2016 Postclosure Groundwater Monitoring and Inspection Report, Central Nevada Test Area, Nevada, Subsurface Corrective Action Unit 443

December 2017

NDEP Correspondence with Record of Review and Response to Comments

Figure 8. Water Elevations for the Well and Piezometers Screened in the Volcanic Section at or near the Depth of the Detonation

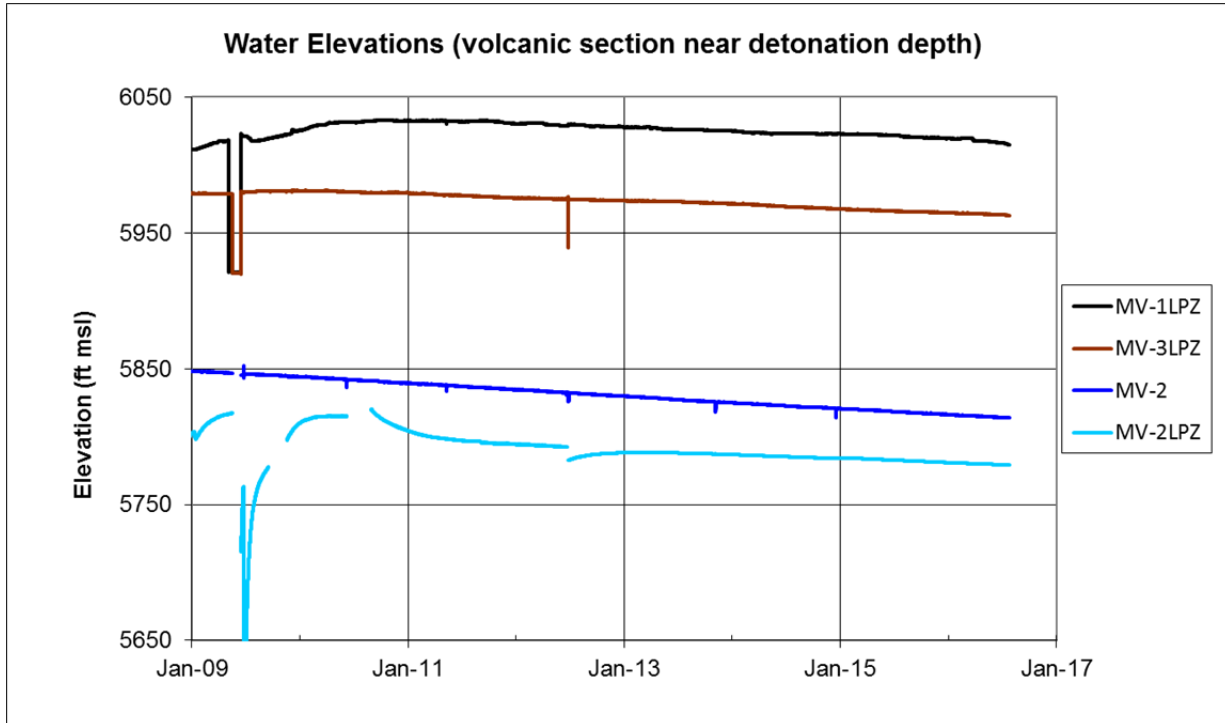
The highly variable water levels in the MV-2LPZ (Figure 8) were investigated by Desert Research Institute on August 5, 2008. They ran a temperature log, collected a bailed sample, and measured the depth of the lower piezometer (MV-2LPZ). It was determined that sediment had filled MV-2LPZ to a depth 75 ft above the top of the screened interval. Additional development of this piezometer in the summer of 2009 lowered the sediment fill to the top of the screened interval. Water elevations in MV-2LPZ appeared to recover in 2010 from the development, then steadily declined (at a decreasing rate) through 2011 and into 2012, when the water level dropped approximately 10 ft after well MV-2 was sampled. After this monitoring event, the water levels in the lower piezometer MV-2LPZ recovered and then reverted to a decreasing trend. The proximity of the MV-2LPZ screened interval to the northwest-bounding graben fault is believed to be the cause of its erratic water levels. It is expected that water levels southeast of this fault (within the graben) are higher than water levels to the northwest, outside the graben. The abrupt water level increase (MV-2LPZ) in June 2010 followed by an abrupt decrease in June 2012 is the result of the installation (2010) and subsequent removal (2012) of a direct-read transducer with a ¼-inch cable. The transducer was placed more than 200 ft below water in case another sudden water level drop like the one in 2008 were to occur. The slow recovery of water
